VoicePrism Plus Noise Solution

Problem Description:

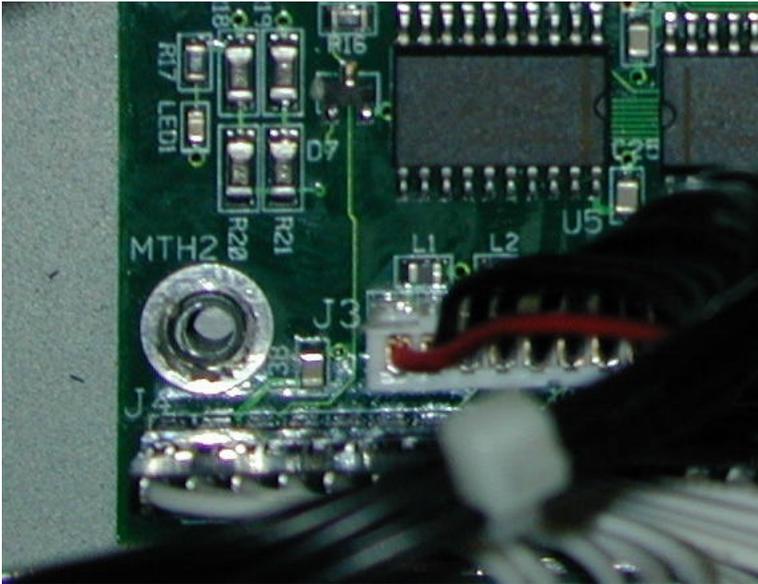
VoicePrism Plus has substantially noisier output when the VoiceCraft Card is connected to the back panel than when it is disconnected.

Connect MTH2 to ground.

1. Open top cover of VoicePrism Plus.
2. Locate MTH2 mounting hole near the front of the unit on the side of the power supply. (see bottom right hand corner of picture below)
